Technical Service Bulletin

When using a Luk-style cover on the 1994-97 7.3-liter Ford F250-450; Remove the clutch-to-flywheel dowel pins prior to installation. They are unnecessary because the clutch is designed to center itself using the shoulder of the original-equipment mounting bolts.

Arrows indicate locating holes.

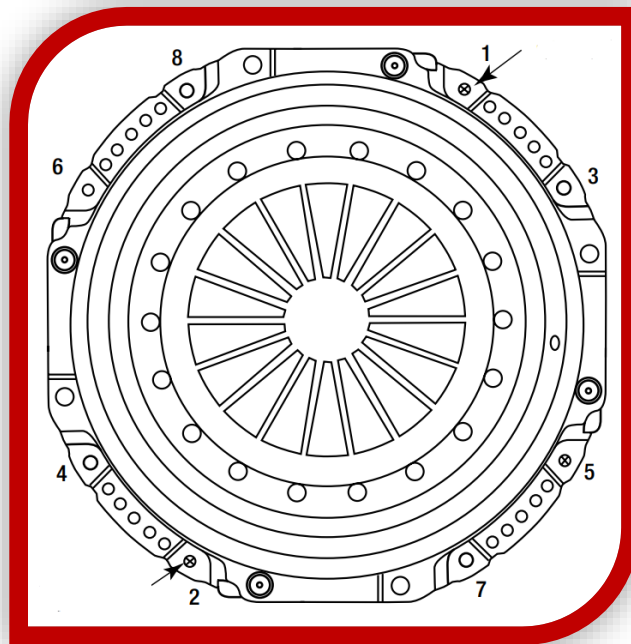
If the dowel pins are not removed, they will cause interference with the clutch cover. When tightening the clutch, ensure you draw the clutch down following the numbered pattern below. By starting the sequence with the two locating holes the clutch will be centered to the flywheel bolt circle. It is important that the clutch be tightened in even increments, using only hand tools, to minimize distortion of the cover.

The torque specification for the clutch mounting bolts is 15 to 20 ft-lb.
